Addendum NO. 01

Date 5/20/2025
Project Name UCA Millcreek Head Start Renovation
Project Number 2025009
Project Phase Permit/Bid
Project Location 336 E 3900 S. Salt Lake City, UT 84107

PROJECT: UCA – Mechanical Addendum

G001

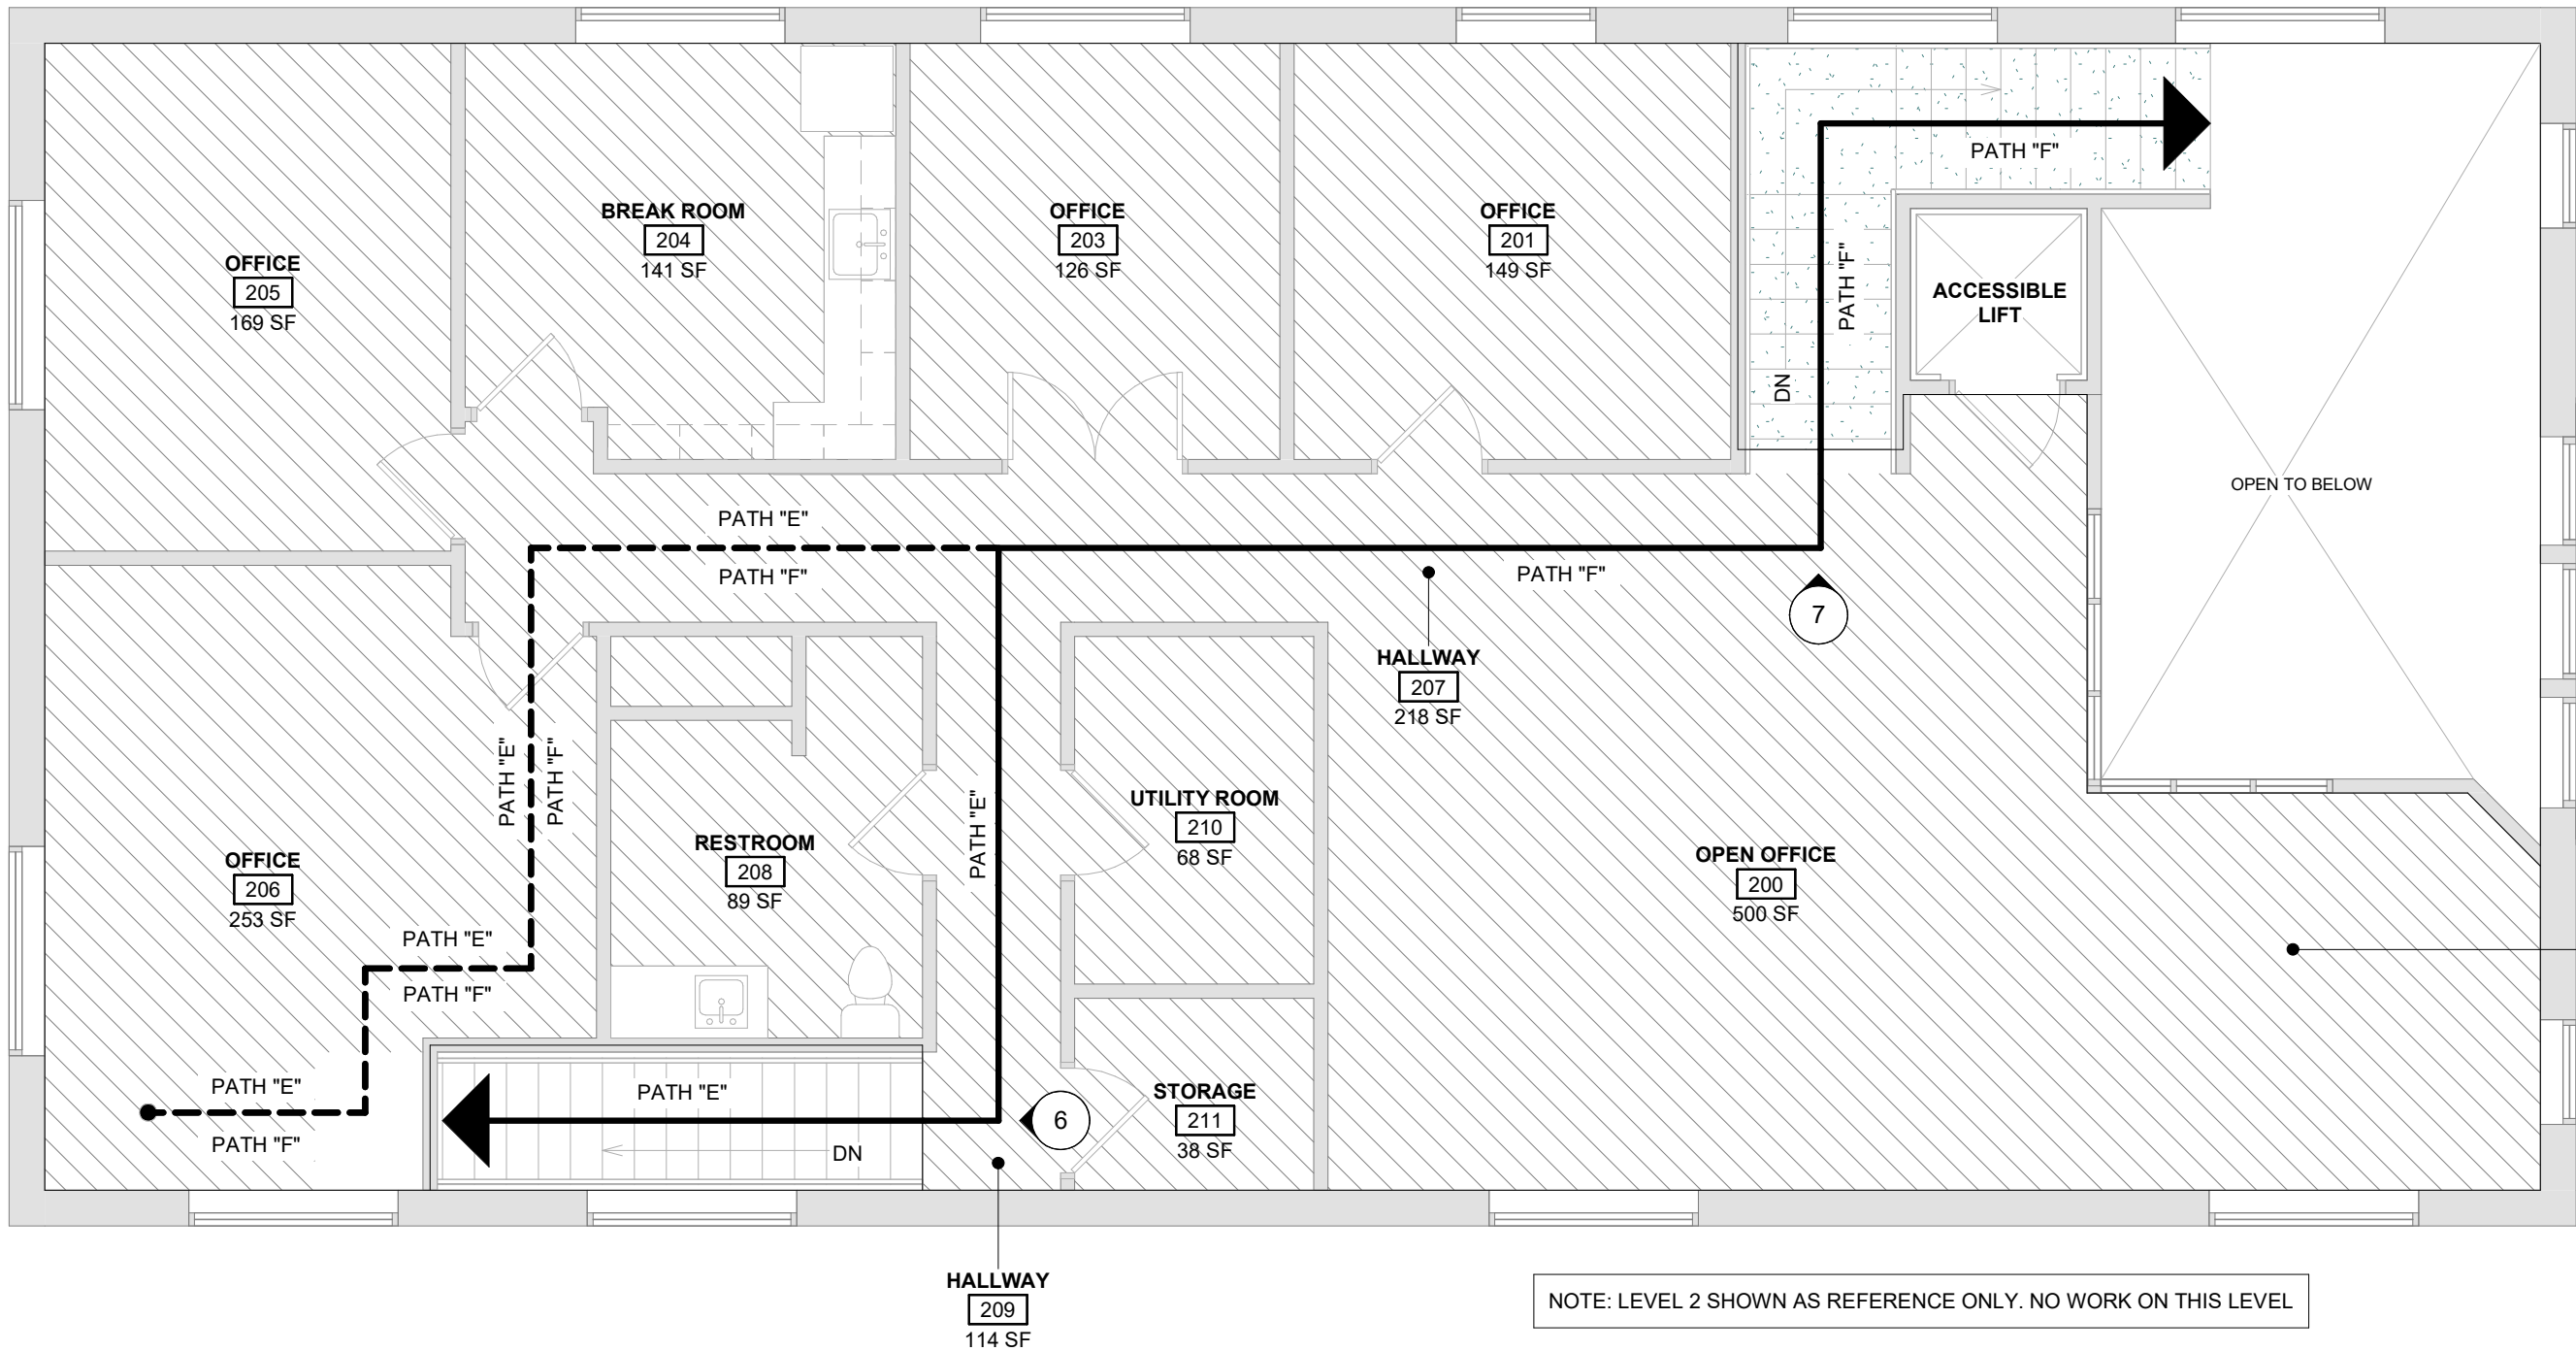
1. **G001 – MATERIAL ID LIST, TYPES AND SYSTEMS**
 - a. BASE TYPES – Revised detail BASE-1.
 - b. BASE TYPES – Added detail BASE-2.
2. **G051 – BUILDING CODE SUMMARY**
 - a. Detail 2/G051 – Revised detail and updated plan locations of single door, exterior windows, and interior walls & millwork based on existing field measurements.
 - b. "EXIT ACCESS PATH DISTANCES" schedule – Revised travel distances.

**1 LEVEL 1 DEMOLITION FLOOR PLAN**
A101 1/4" = 1'-0"

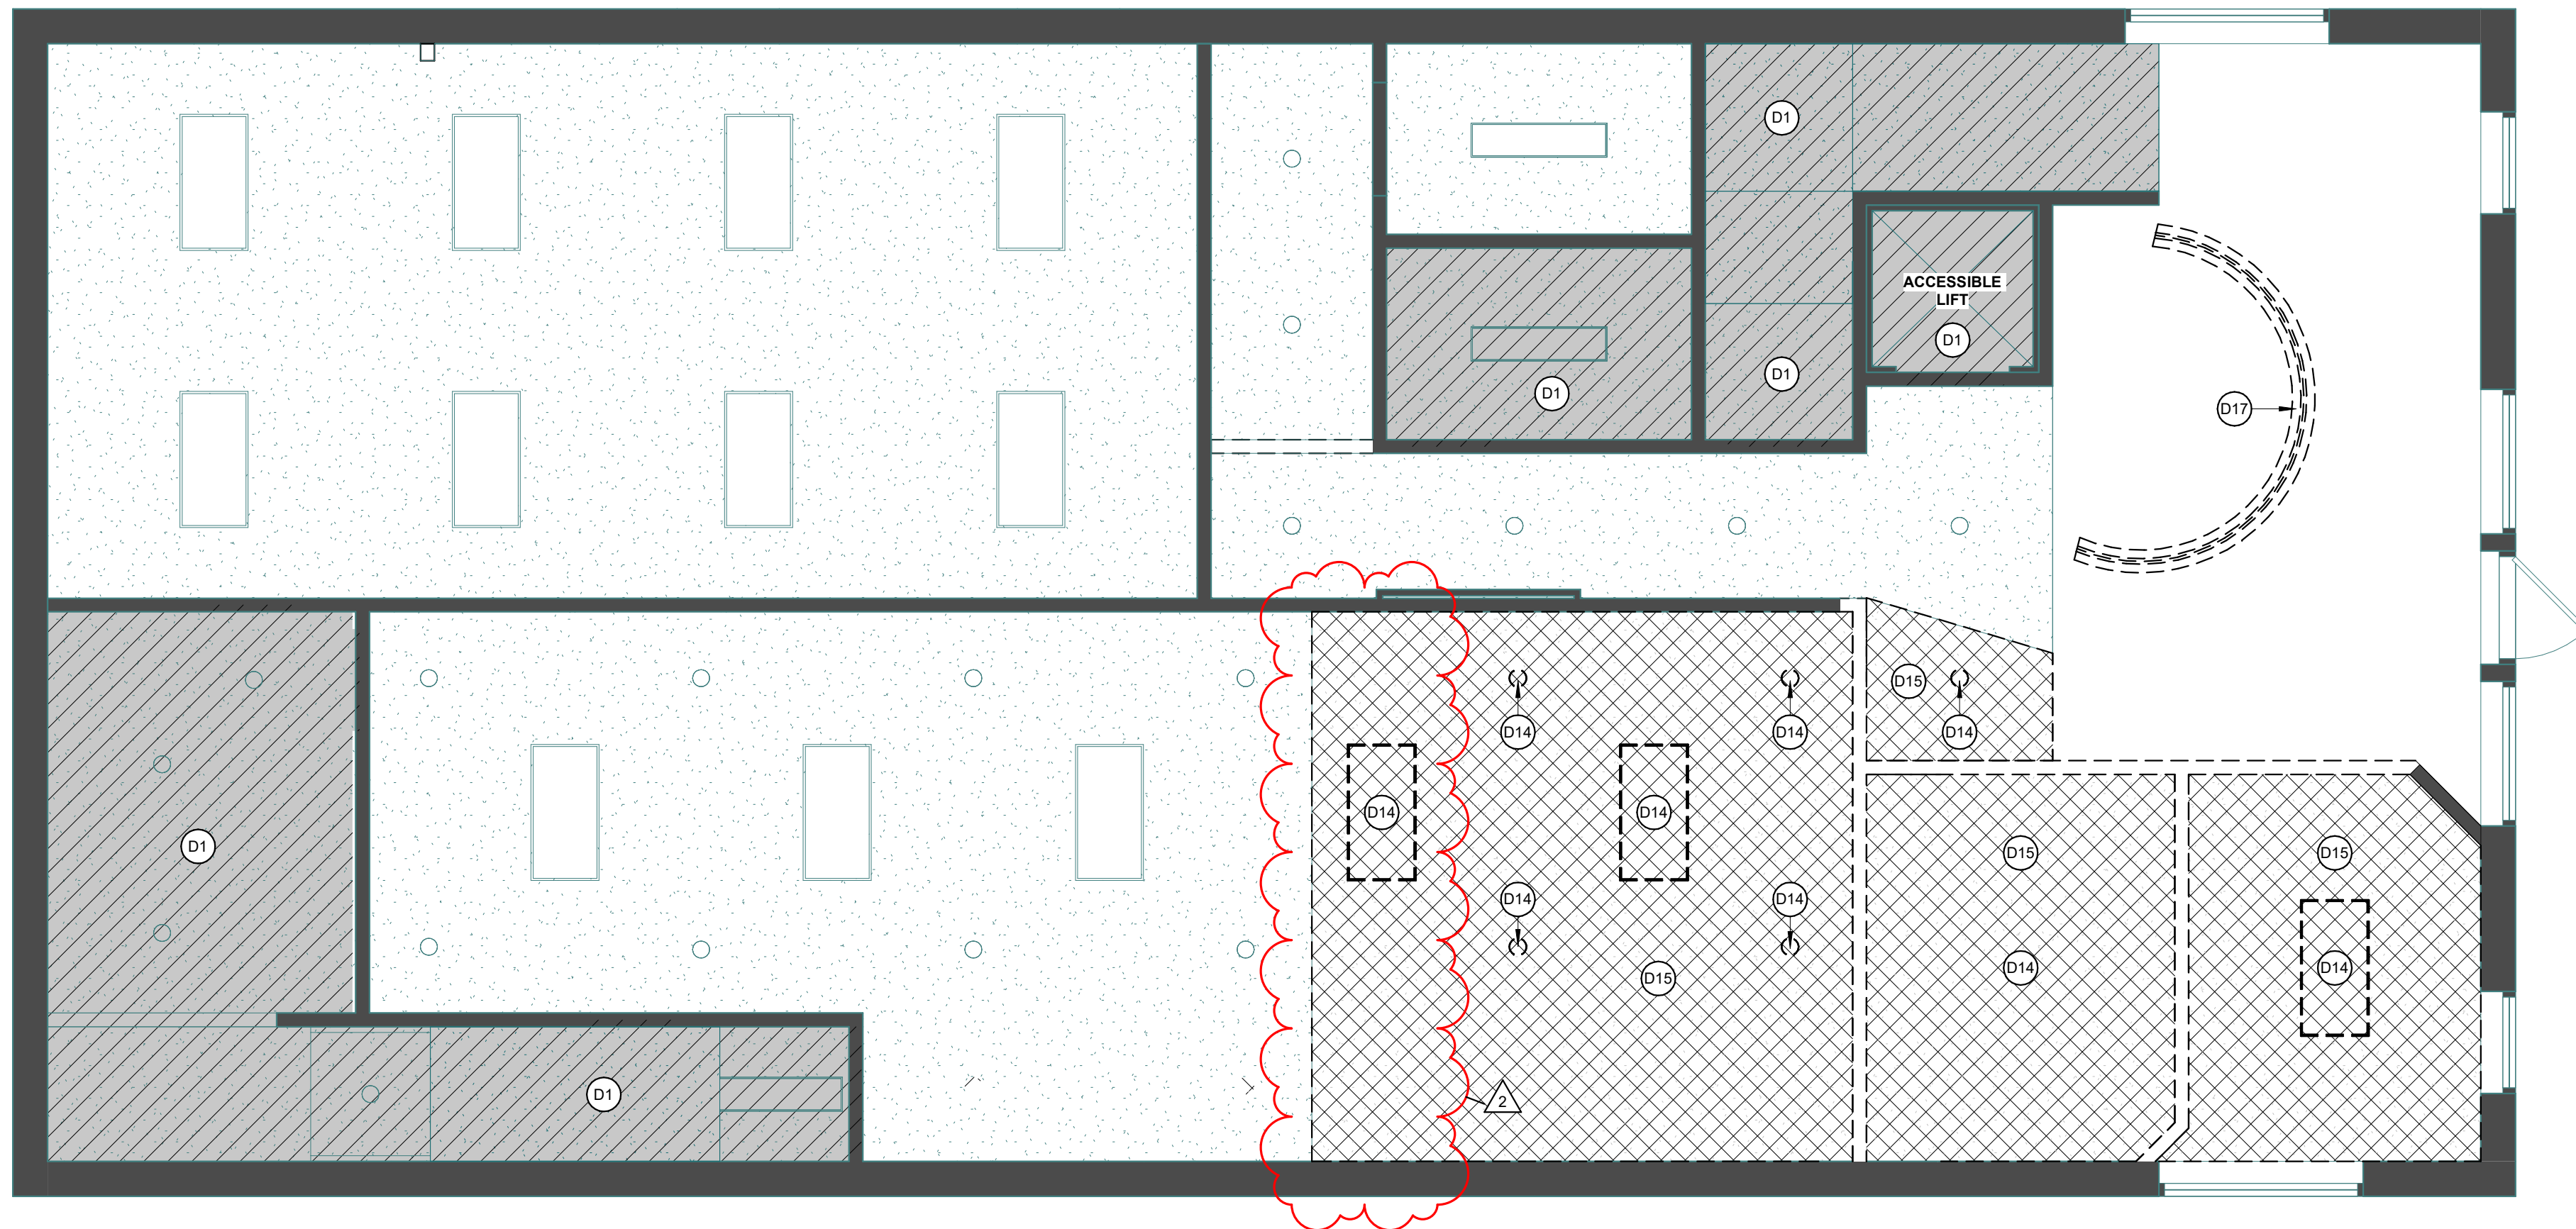
- 3. A101 – LEVEL 1 DEMOLITION FLOOR AND REFLECTED CEILING PLAN**
- a. Detail 1/A101 – Revised detail and updated plan locations of single door, exterior windows, and interior walls & millwork based on existing field measurements.

**2 LEVEL 1 DEMOLITION REFLECTED CEILING PLAN**
A101 1/4" = 1'-0"

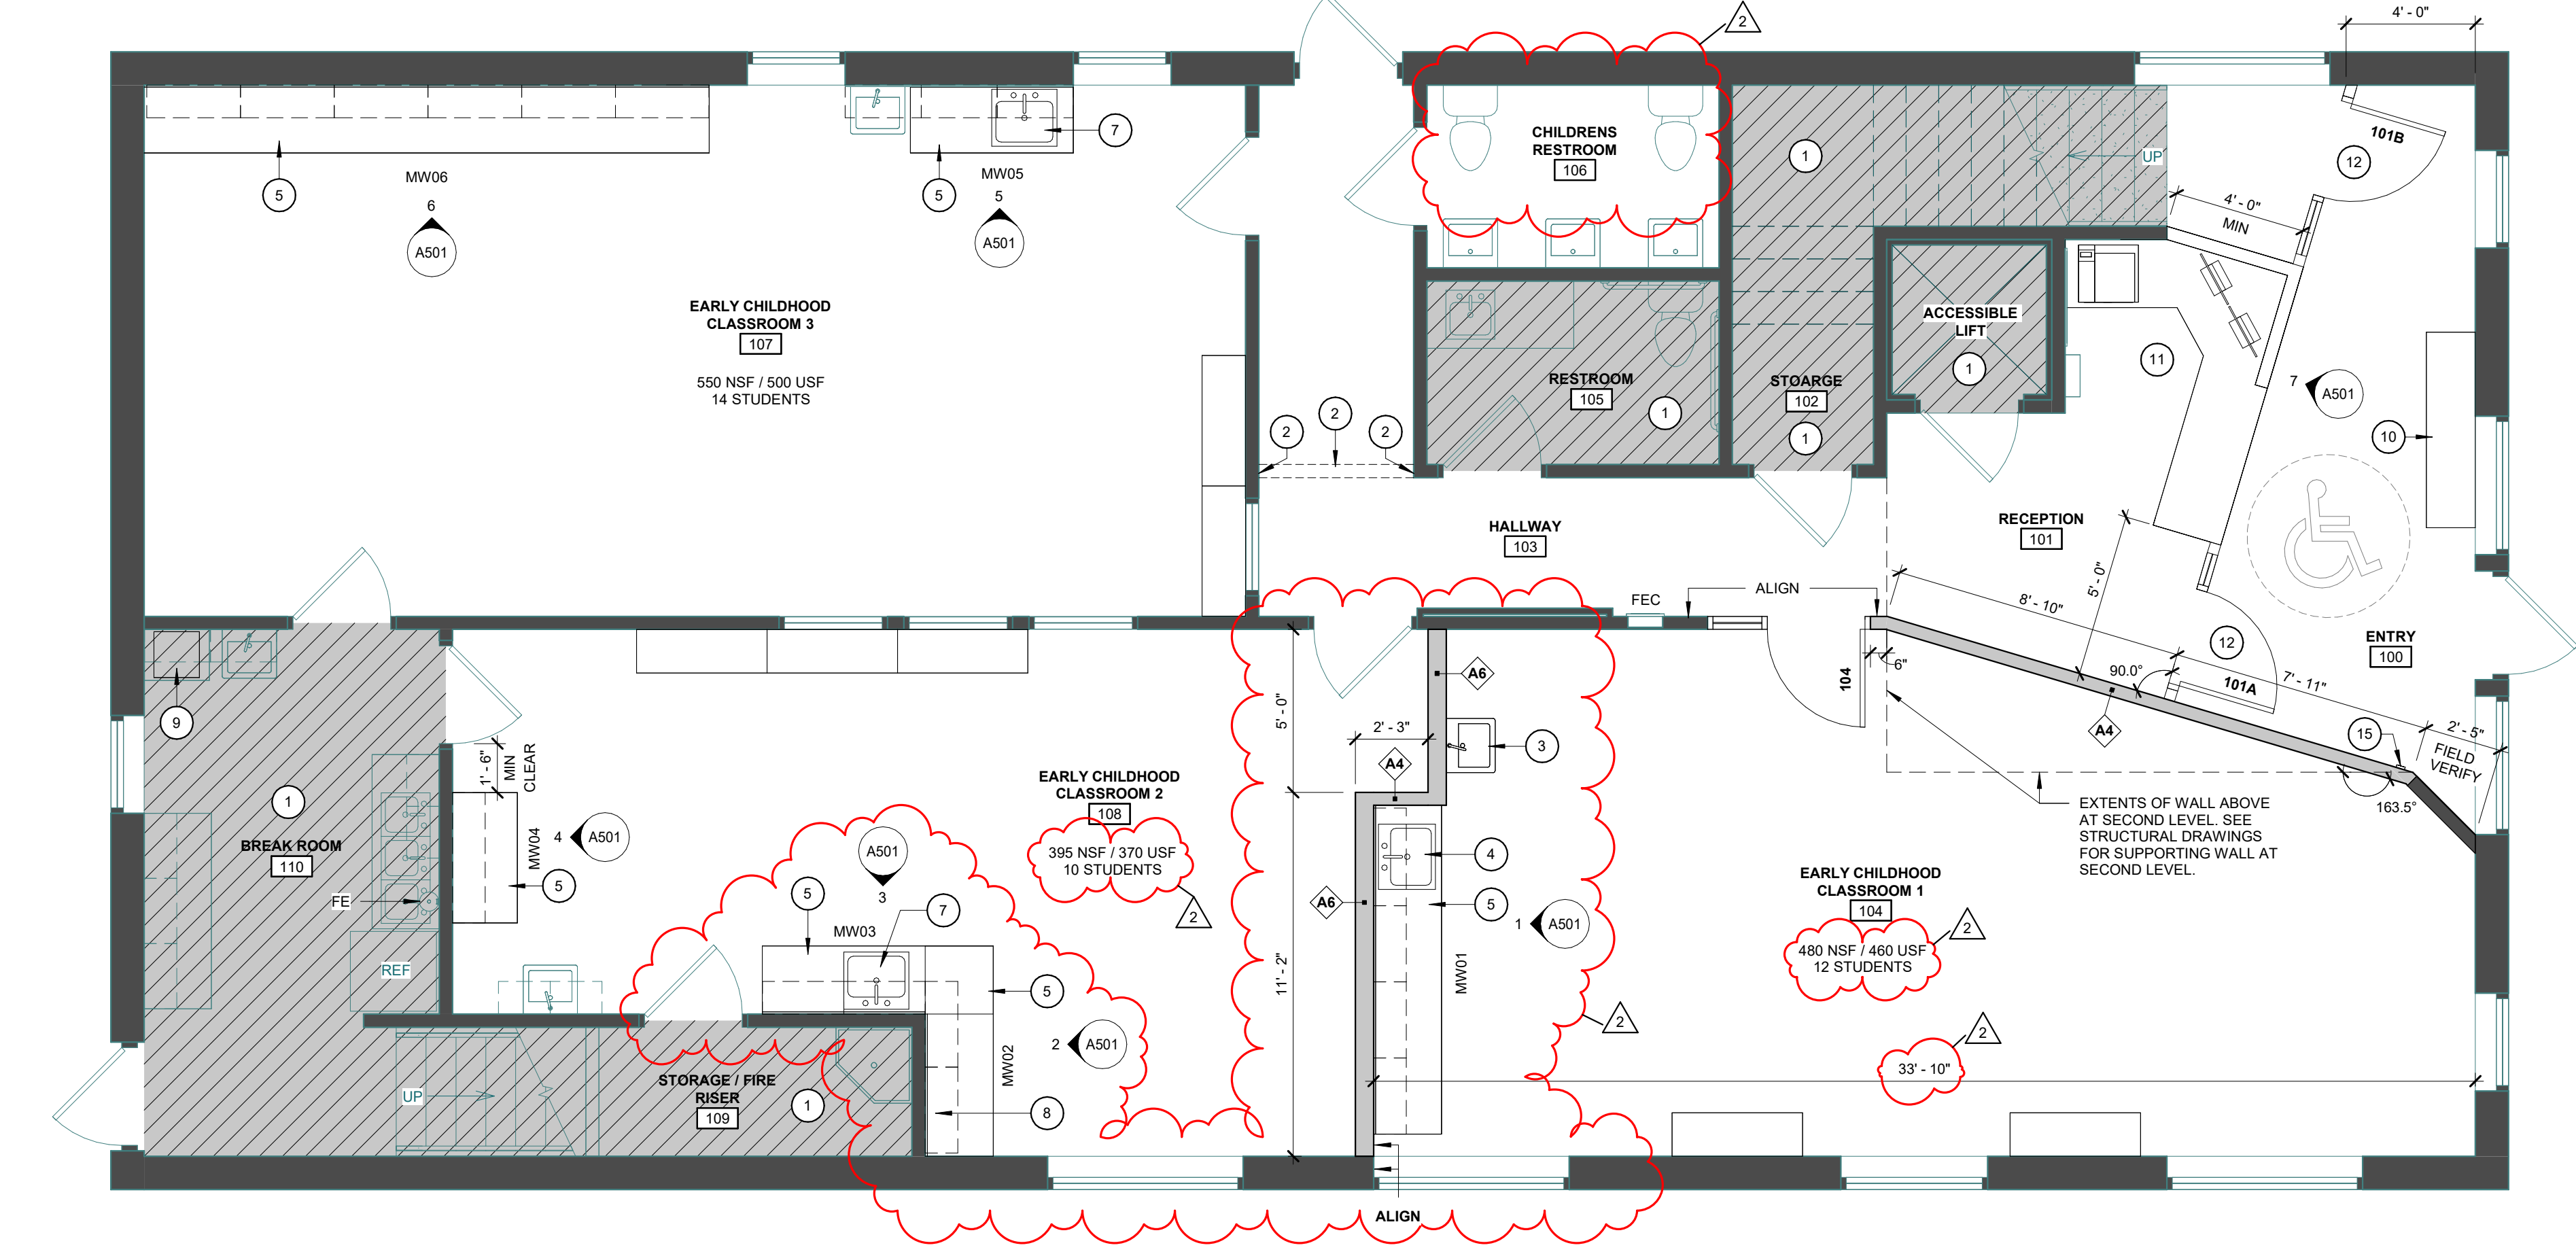
- b. Detail 2/A101 – Revised extent of ceiling removal between Early Childhood Classrooms 1 & 2.
 - c. Demolition Keynote D13 – Revised Keynote to read "NOT USED".
